Vermont Agency of Transportation
RECEIVED
 CK'D BY JG, RF OK'D BY GL
 February 2, 2016
 RESUBMIT YES Rejected
 BY KH DATE 2-23-2016

GUARD RAIL TO BRIDGE RAIL TRANSITION

SPECIAL PROVISION, GRAS - CONCRETE COMBINATION BR.
 ROUTE NO. T.H. 3 (CLASS 2), RURAL COLLECTOR, BRIDGE # 11
 TOWN OF CLARENDON, RUTLAND COUNTY, VT.

ITEM #: 900.620 SHEET 6 OF 9

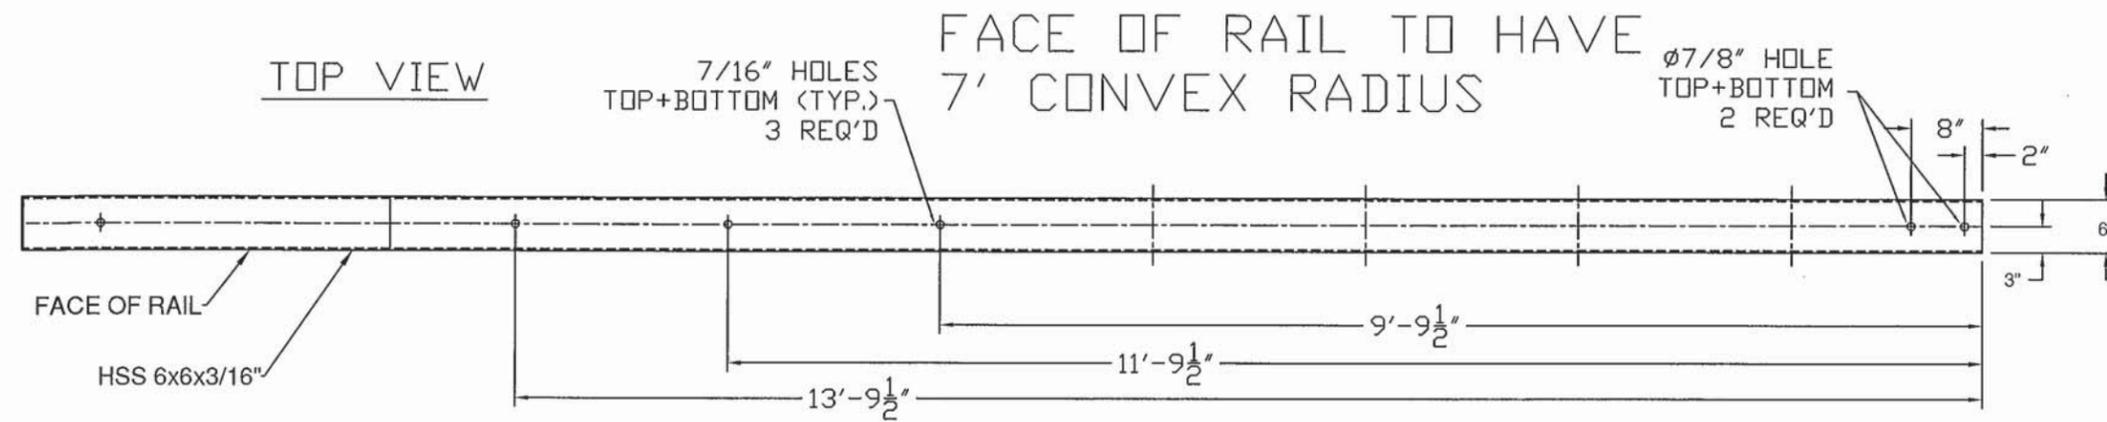
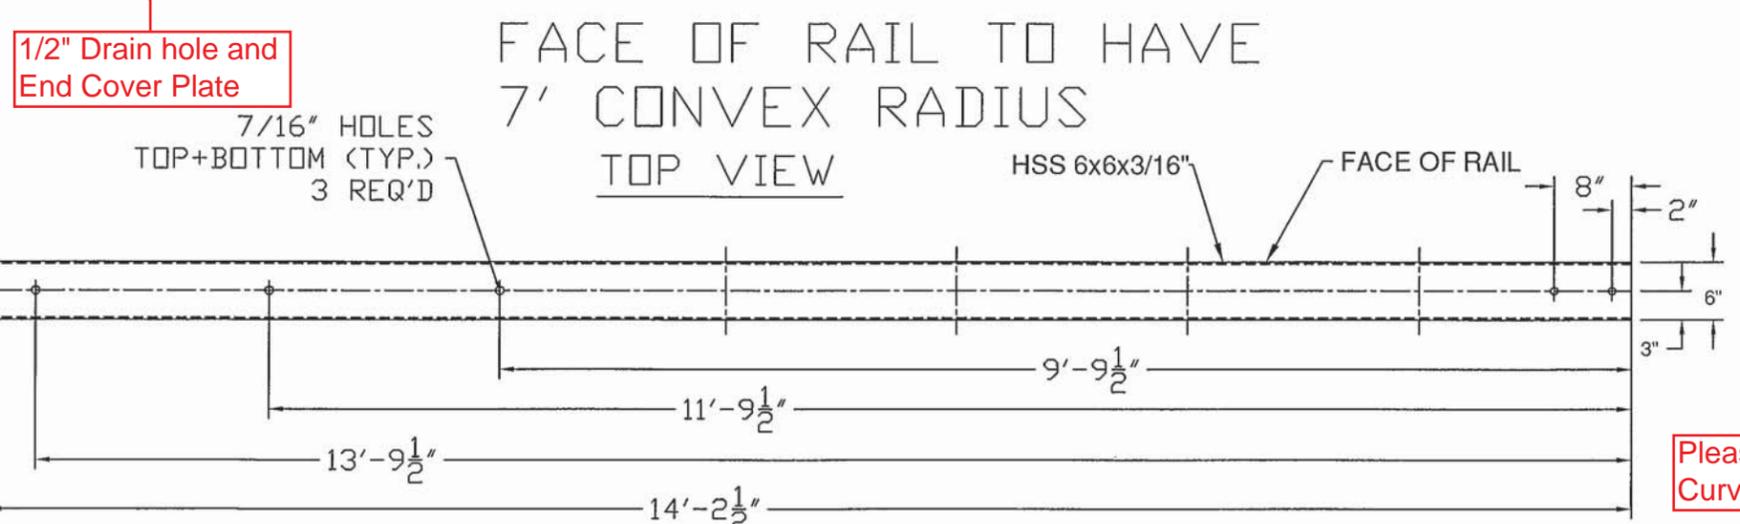
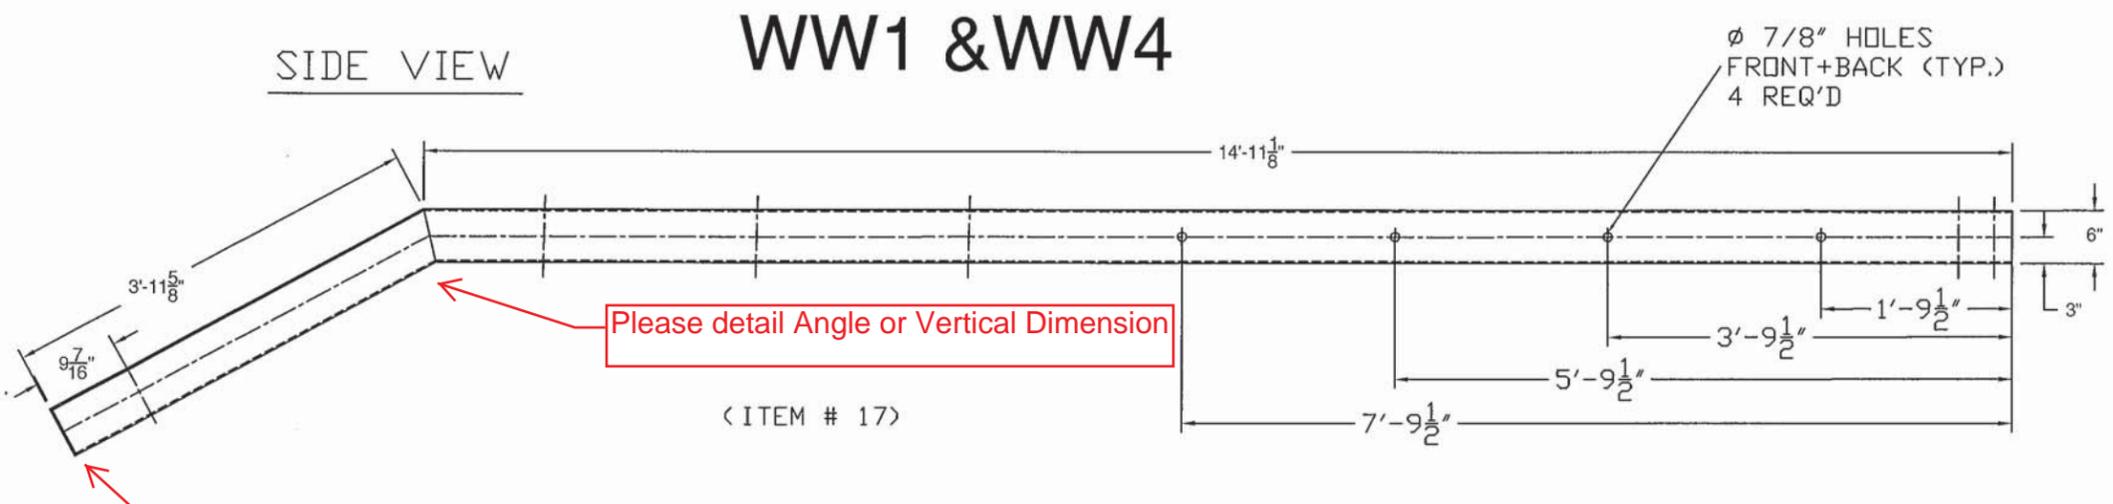
Wing Wall 1 Approach Rail will need to be bent in the vertical direction as well. Theoretical Ground Elevations are given at each post location on sheet 20 of the Contract Plans.

Please Detail Points of Curvature on Box Beam

Please Detail Points of Curvature on Box Beam

Label as Item 900.620 Special Provision (Guardrail Approach Section to Concrete Bridge Railing).

ITEM #: 900.620 SHEET 7 OF 9

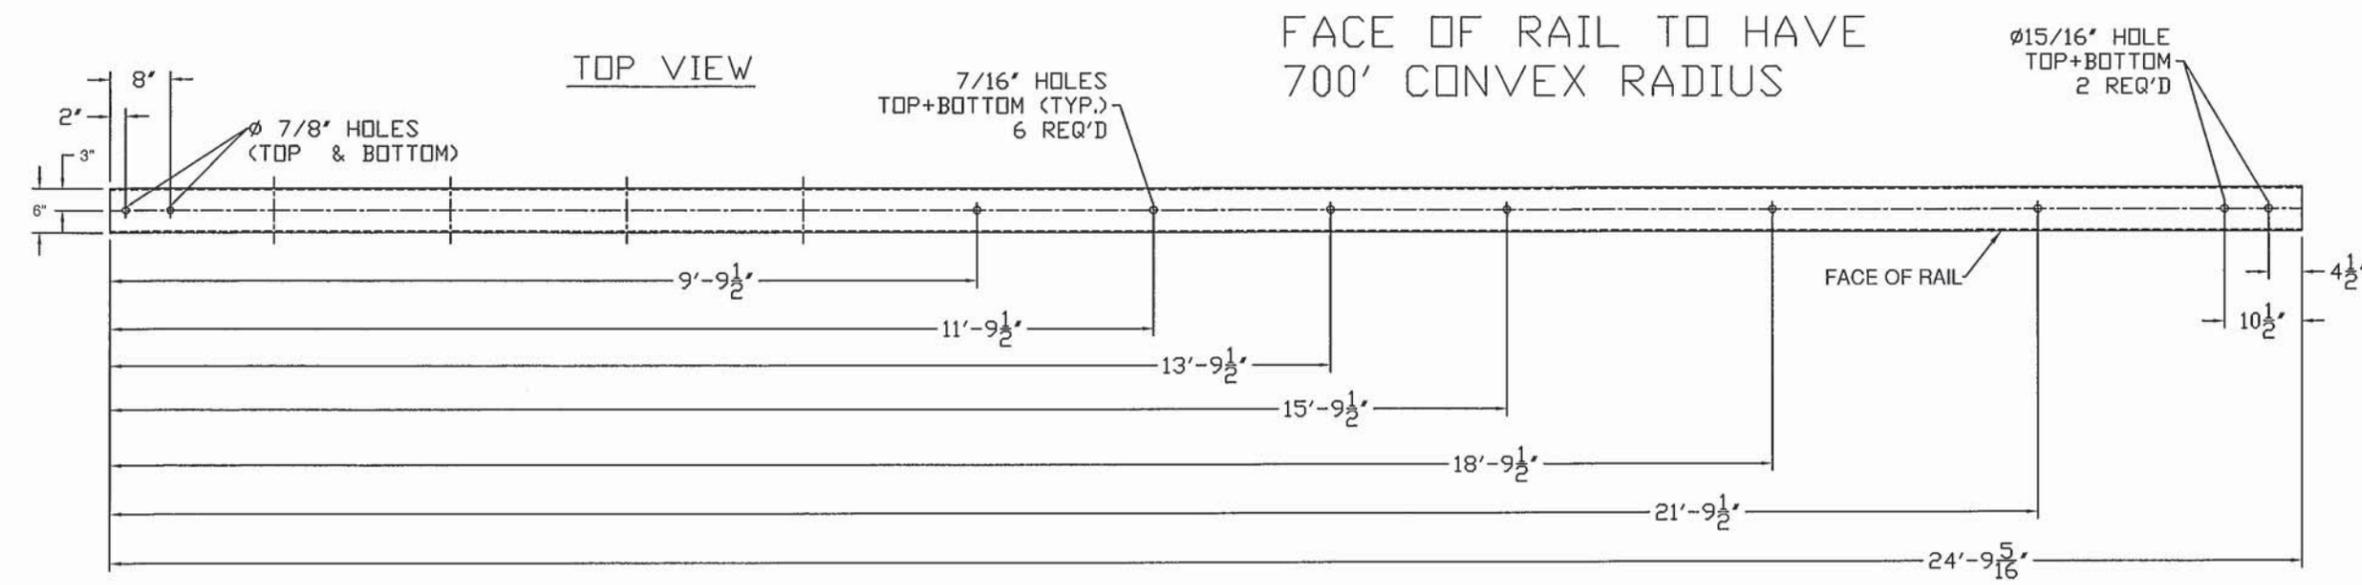
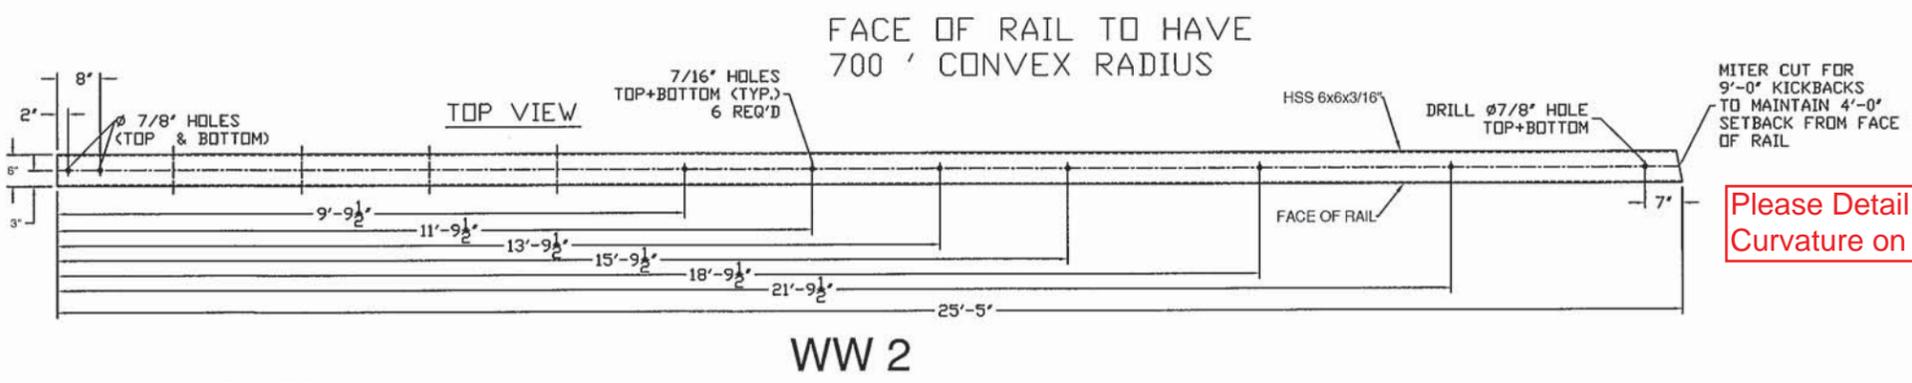
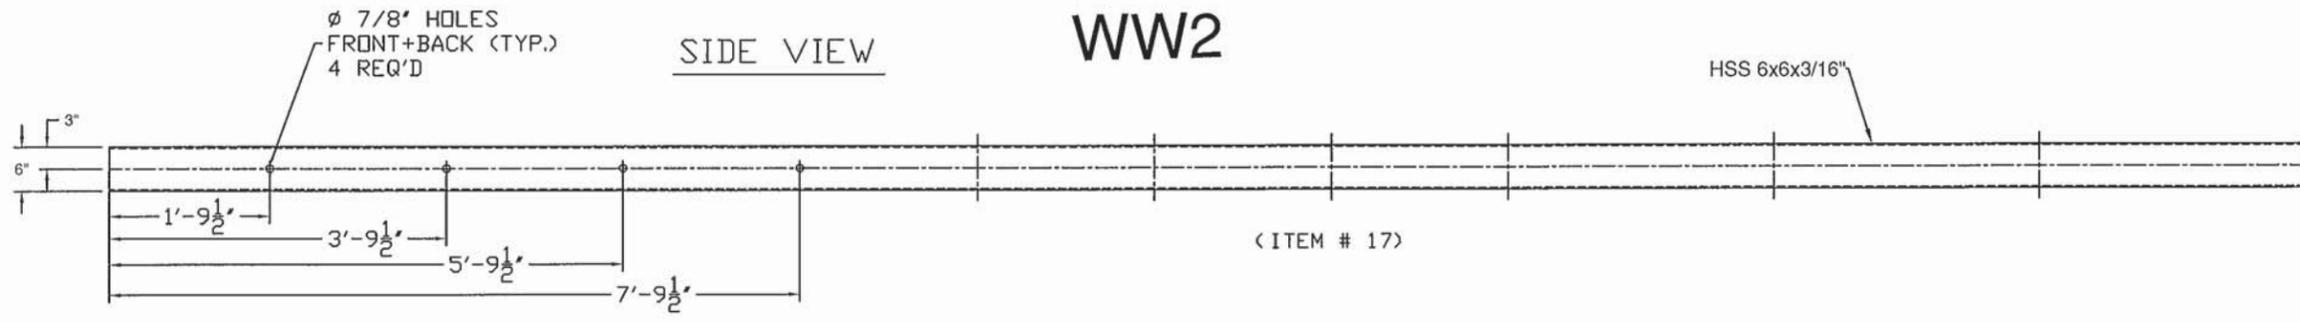
Please Detail Points of Curvature on Box Beam

Please Detail Points of Curvature on Box Beam

Label as Item 900.620 Special Provision (Guardrail Approach Section to Concrete Bridge Railing).

MITER CUT FOR 9'-0" KICKBACKS TO MAINTAIN 4'-0" SETBACK FROM FACE OF RAIL

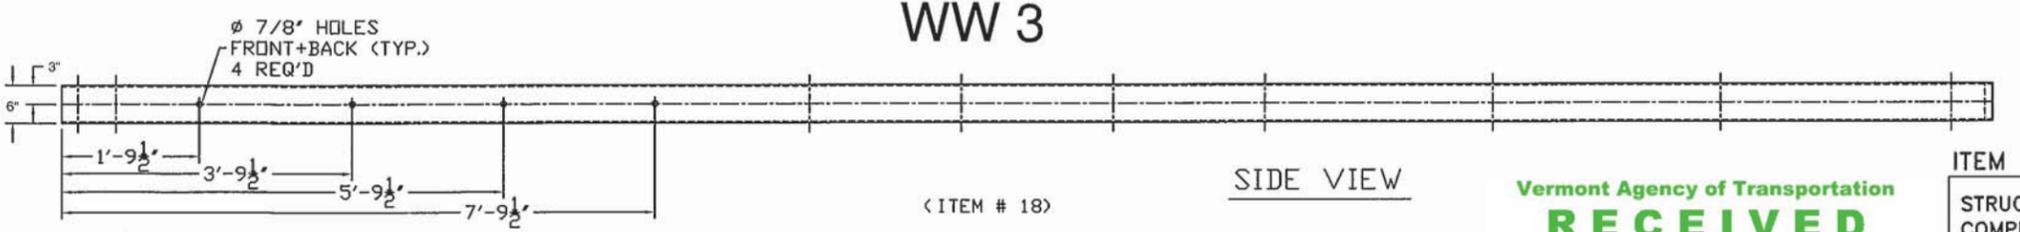
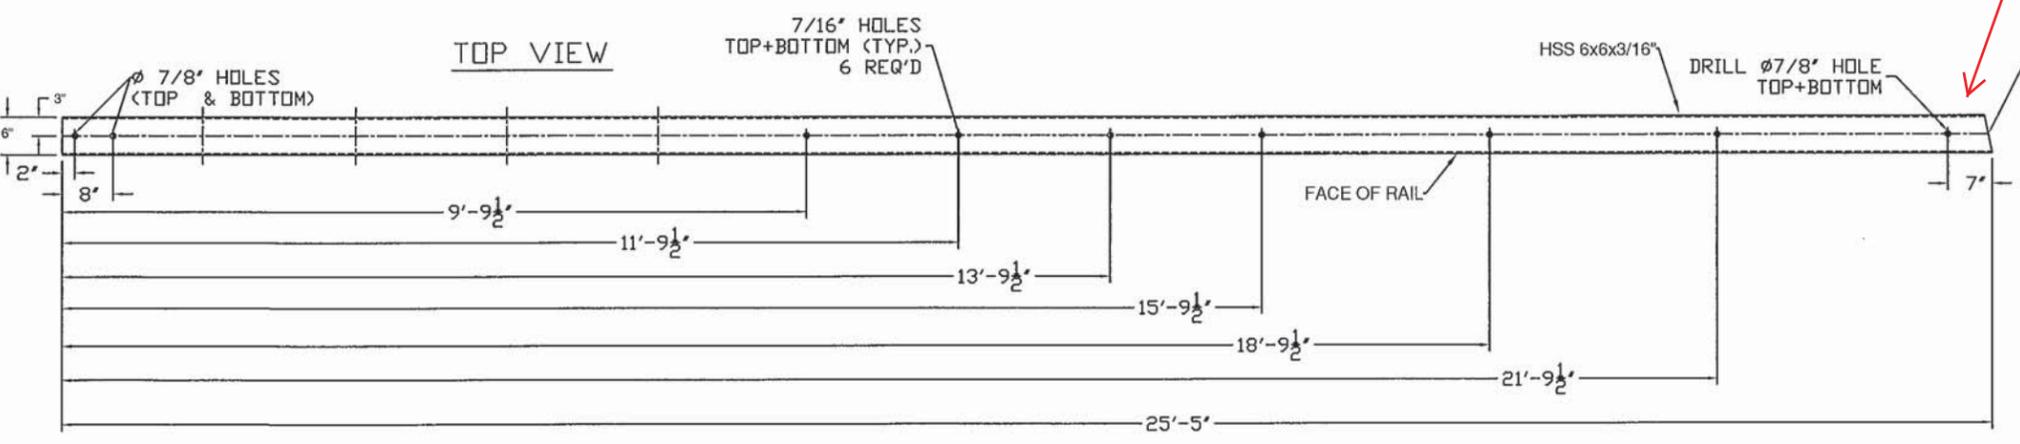
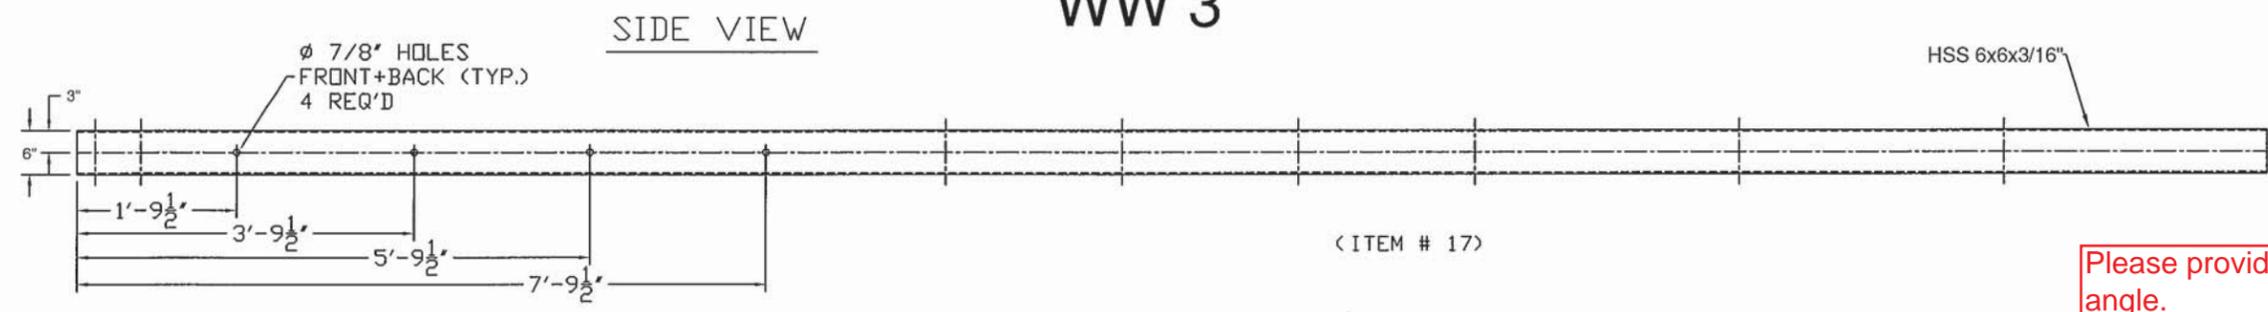
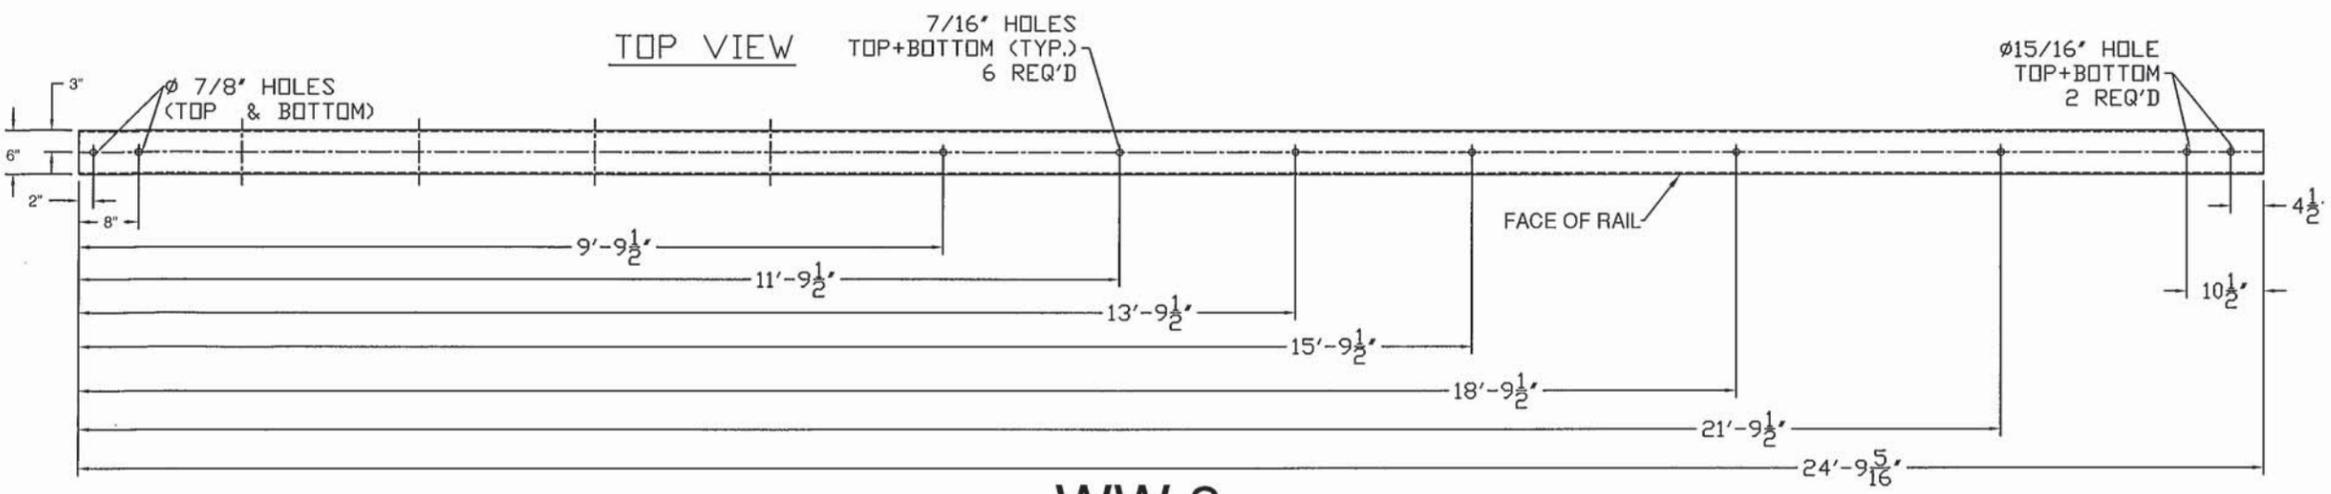
Please provide a miter cut angle.

Label as Item 900.620 Special Provision (Guardrail Approach Section to Concrete Bridge Railing).
